**RESOLUTION No. 12/13-35
CITY OF DAYTON, OREGON**

Title: A Resolution Adopting Public Works Design Standards Update No. 5

SUBJECT: Public Works Design Standards Update No. 5

LAST REVISION DATE: APR 2012	COPYRIGHT 1996 WESTECH ENGINEERING, INC.
STANDARD SERVICE LATERAL CLEANOUT	
(NTS)	
DAYTON, OR	DETAIL NO. 416

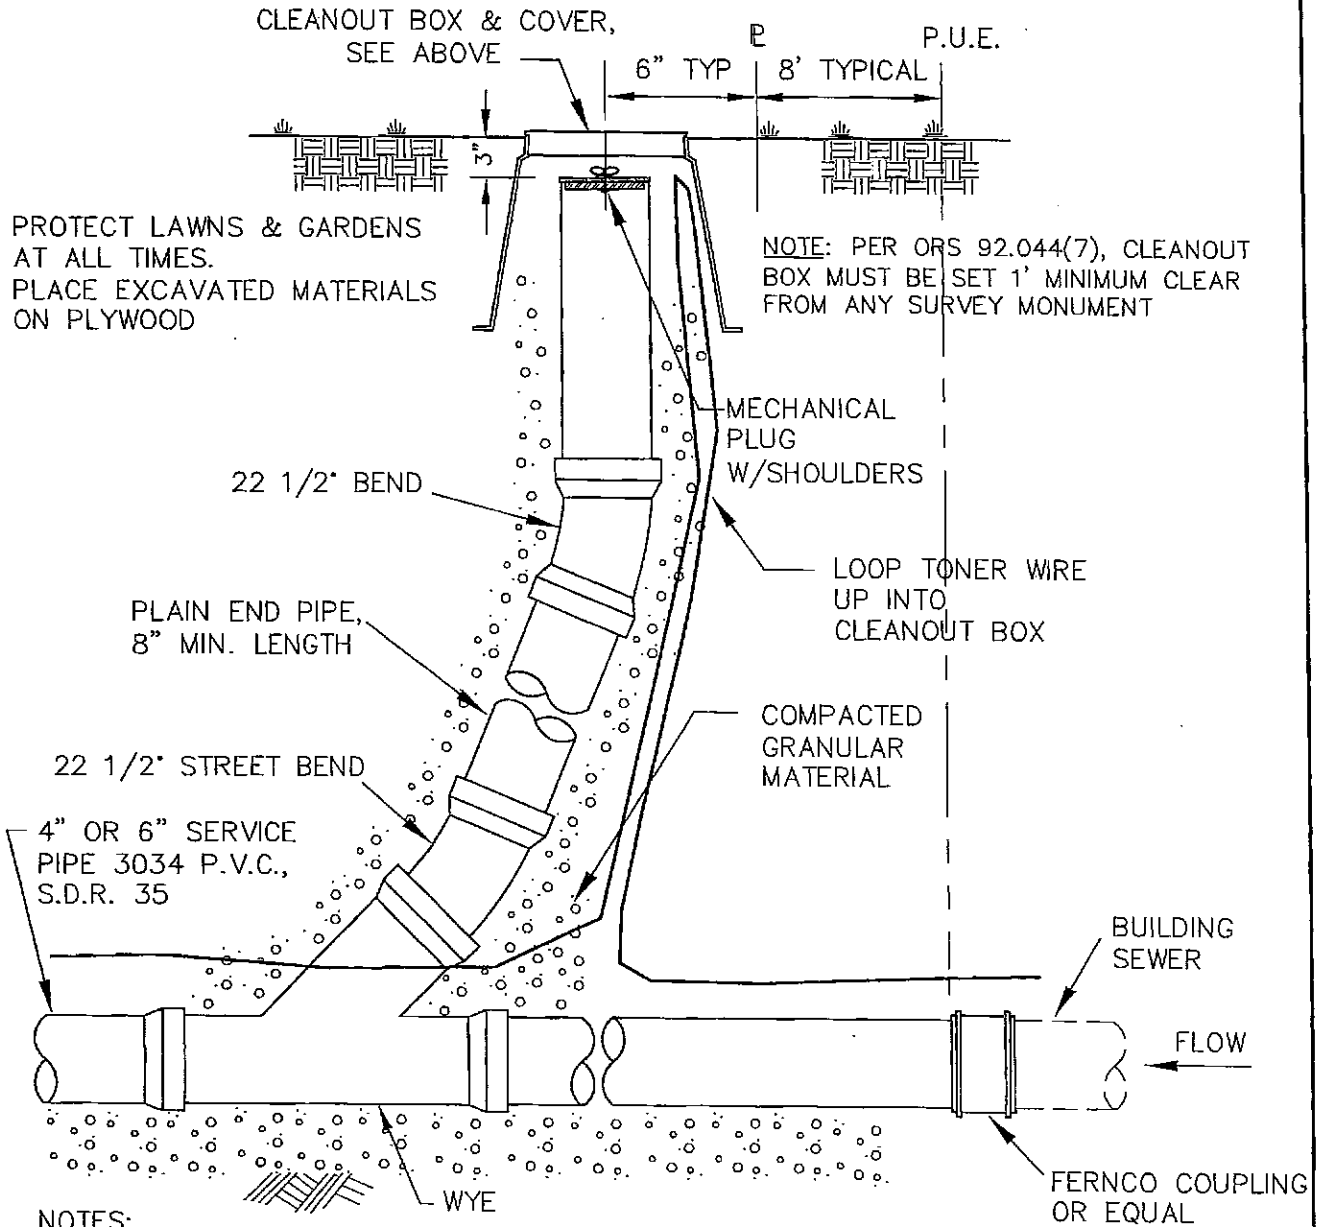
59. Detail 416: The detail notes were modified to clarify that cleanout boxes in traffic areas are to be set in a concrete pad. The revised detail (see attached) is dated 4/12.

LAST REVISION DATE: DEC 2012	JO # STANDARD
INSERTA-TEE CONNECTION TO EXISTING SEWER OR STORM DRAIN (NTS)	
DAYTON, OR	DETAIL NO. 419

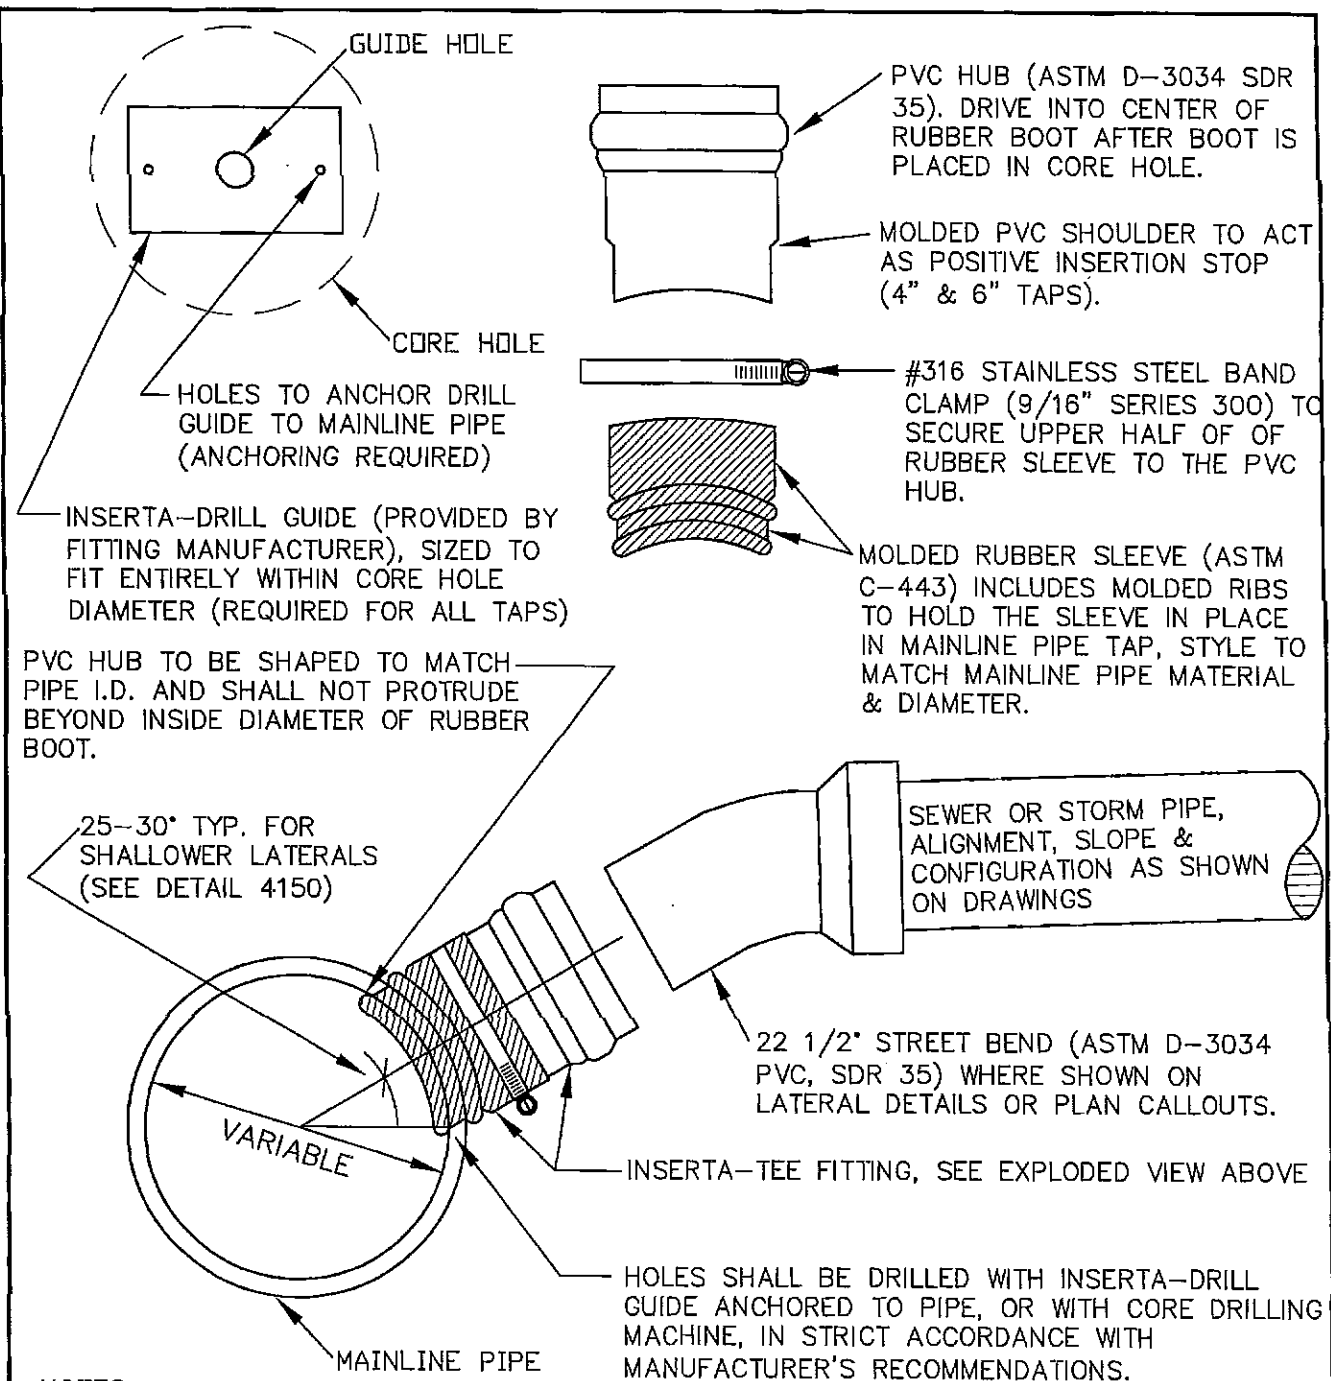
60. Detail 418: This detail was deleted from the PWDS.
61. Detail 419: The detail notes were modified to reflect the configuration of the standard Inset Tee fittings currently manufactured. The revised detail (see attached) is dated 12/12.

LAST REVISION DATE: DEC 2011	JO # STANDARD
GATE VALVE AND VALVE BOX DETAIL	
(NTS)	
DAYTON, OR	DETAIL NO. 501

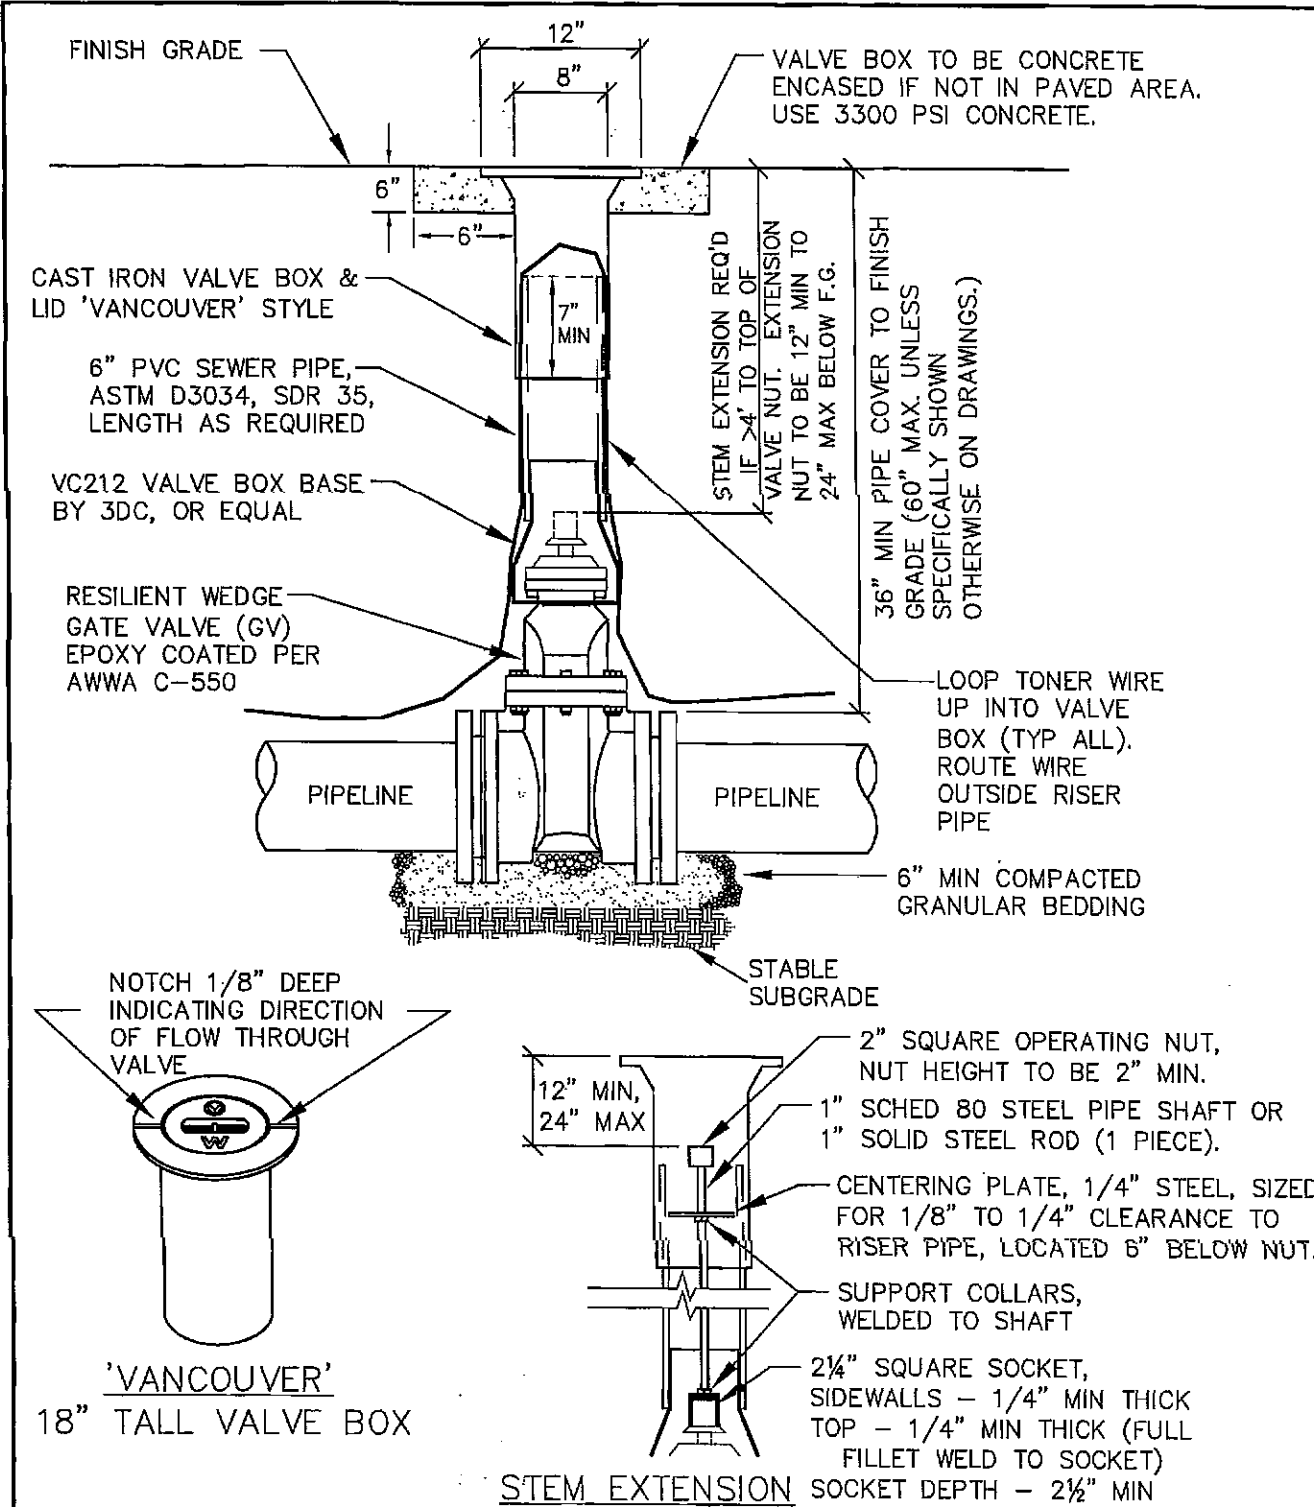
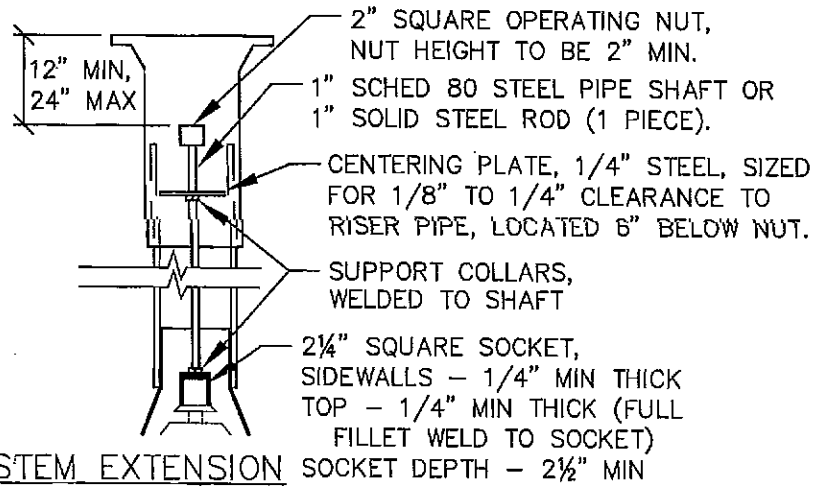
62. Detail 501: The detail callouts were modified to clarify depth to valve nut and toner wire configuration, and to reflect riser stem requirements. The revised detail (see attached) is dated 12/11.

LAST REVISION DATE: NOV 2012	JD # STANDARD
BUTTERFLY VALVE AND VALVE BOX DETAILS	
(NTS)	
DAYTON, OR	DETAIL NO. 502

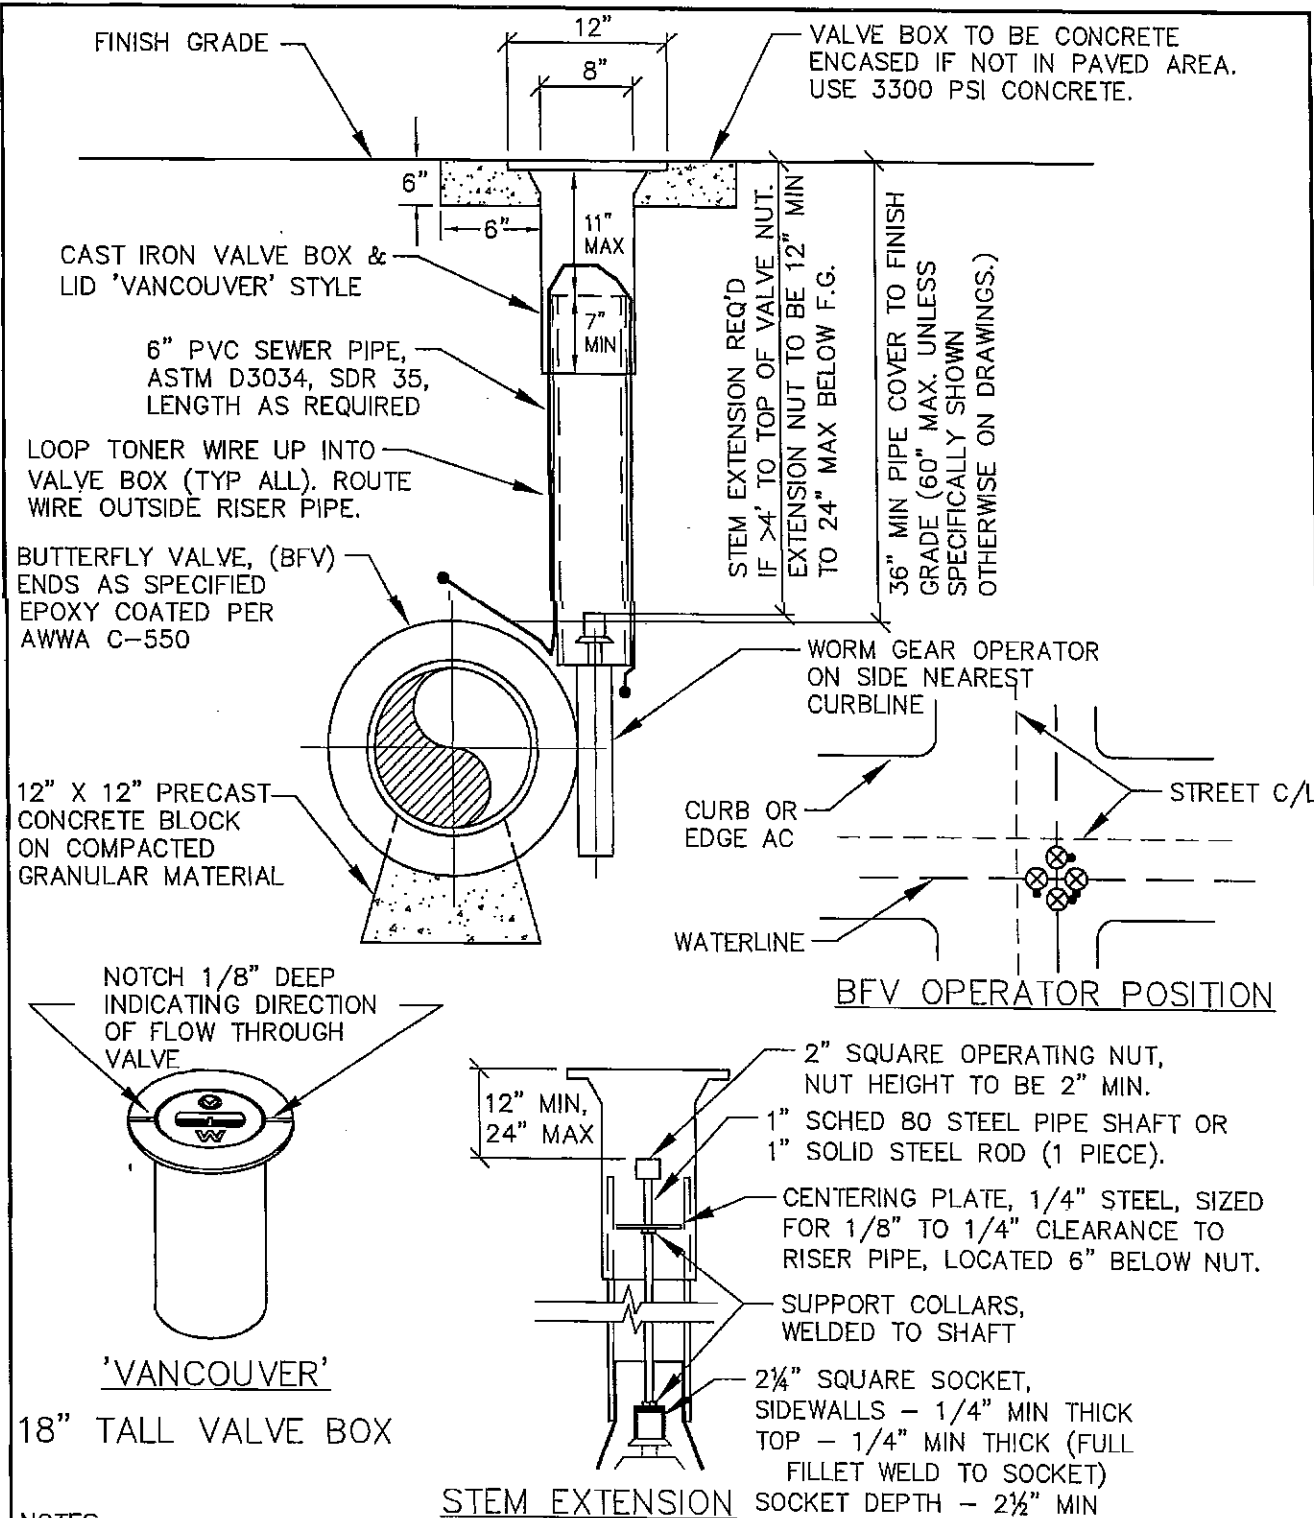
63. Detail 502: The detail callouts were modified to clarify depth to valve nut and toner wire configuration, and to reflect riser stem requirements. The revised detail (see attached) is dated 12/11.

LAST REVISION DATE: SEPT 2010	COPYRIGHT 1996 WESTECH ENGINEERING, INC.
STANDARD FIRE HYDRANT ASSEMBLY	
(NTS)	
DAYTON, OR	DETAIL NO. 503

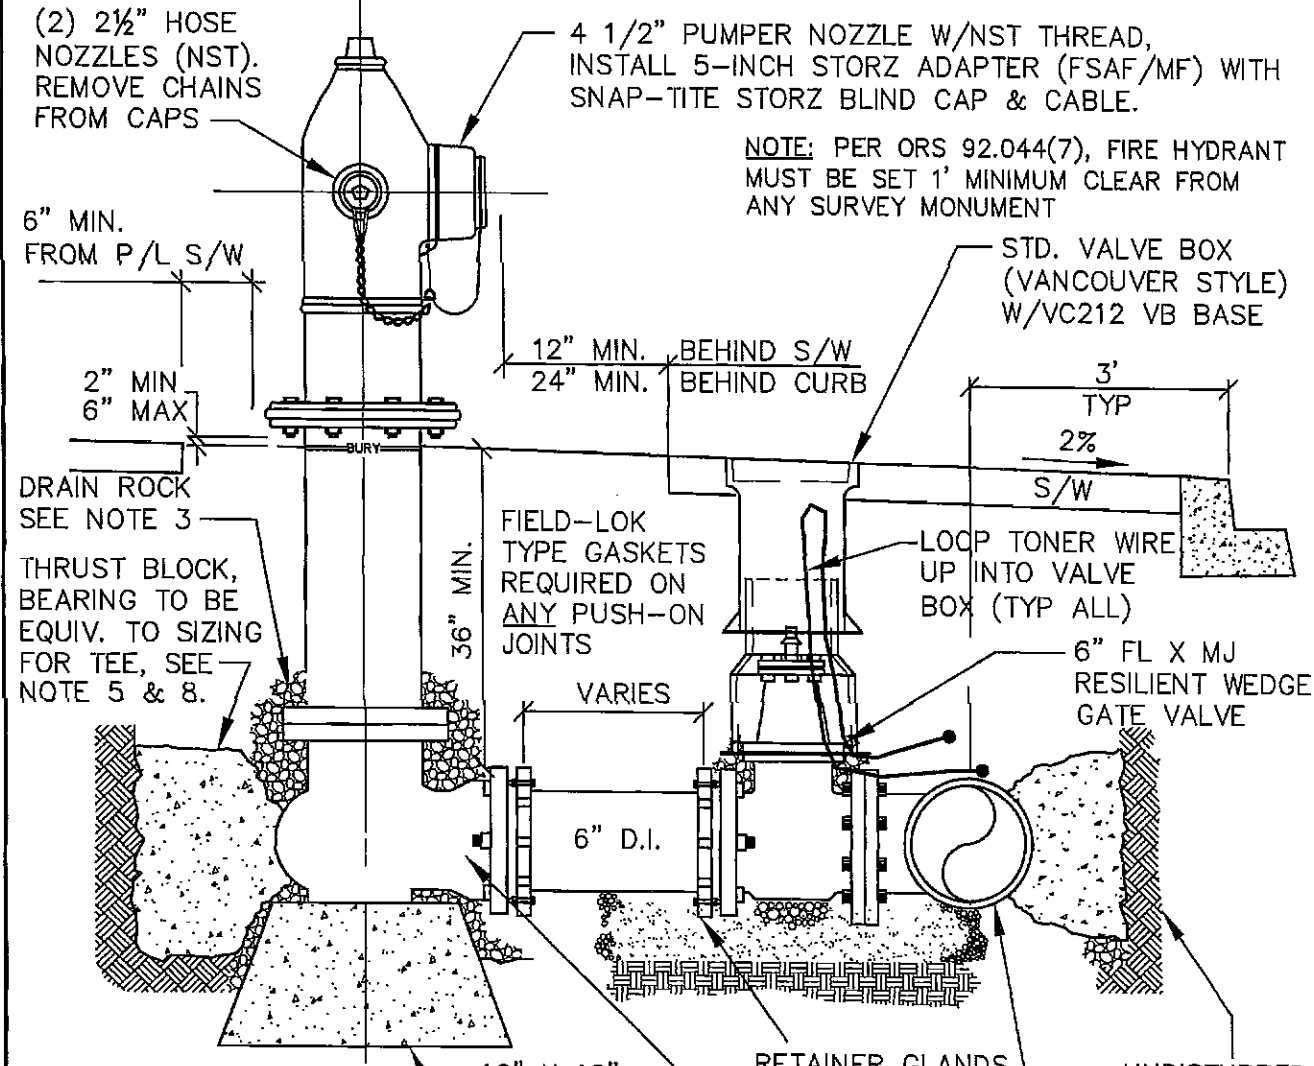
64. Detail 503: The detail notes were modified to specify yellow curb painting at hydrant locations. The revised detail (see attached) is dated 9/10.
65. Detail 505: The detail notes were modified to reflect the standard valve style and standard valve box required for use by other details. The revised detail (see attached) is dated 1/13.

LAST REVISION DATE: FEB 2011	COPYRIGHT 1988 HESTECH ENGINEERING, INC.
TYPICAL 1" WATER SERVICE	
(NTS)	
DAYTON, OR	DETAIL NO. 515

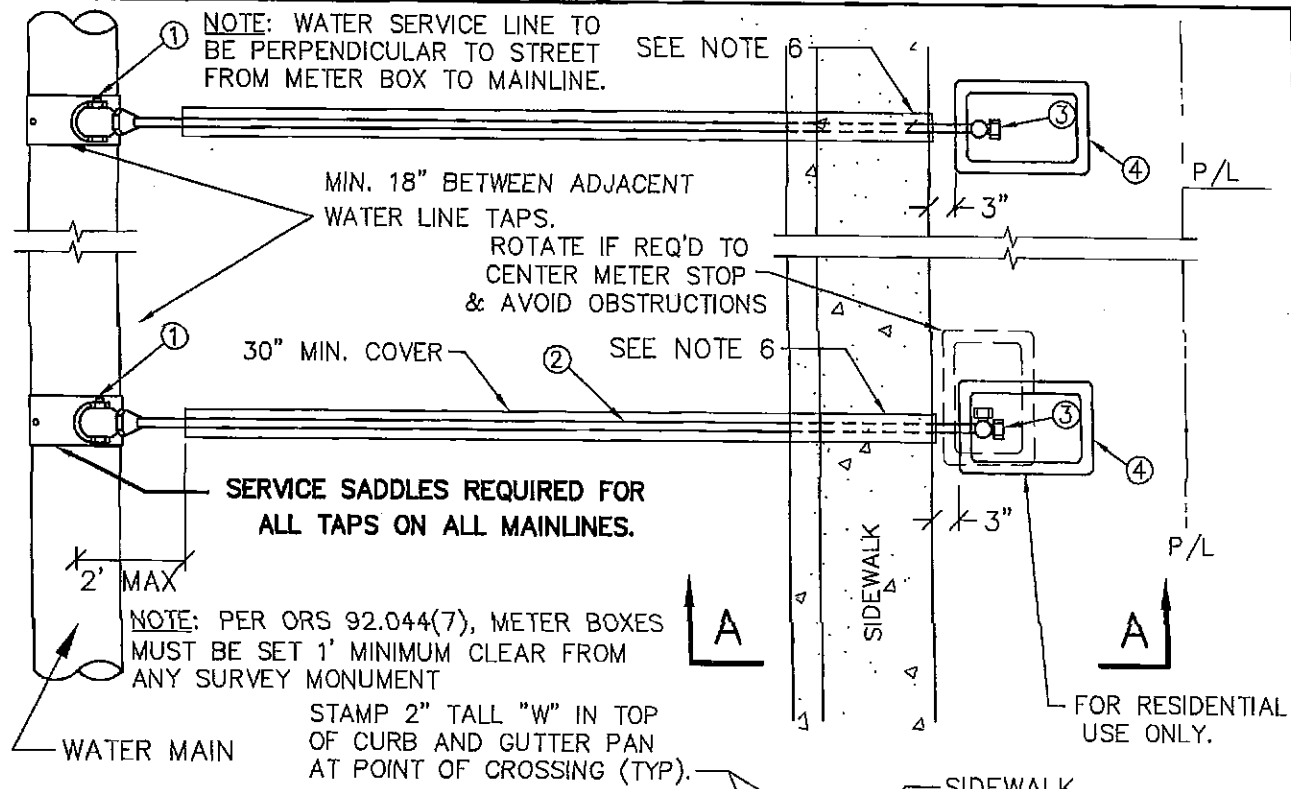
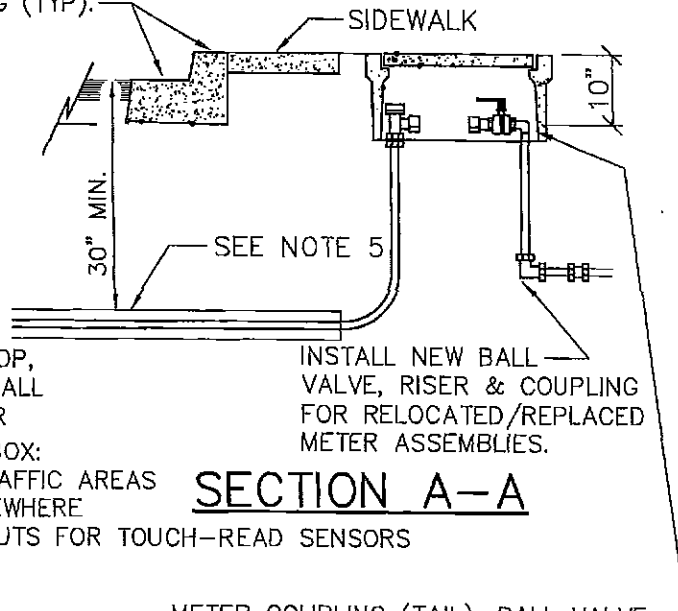
66. Detail 515: The callout number for the box lid was corrected. The revised detail (see attached) is dated 2/11.
67. Detail 517: The meter box drawing was modified to match the configuration shown on Detail 516. The revised detail (see attached) is dated 2/11.
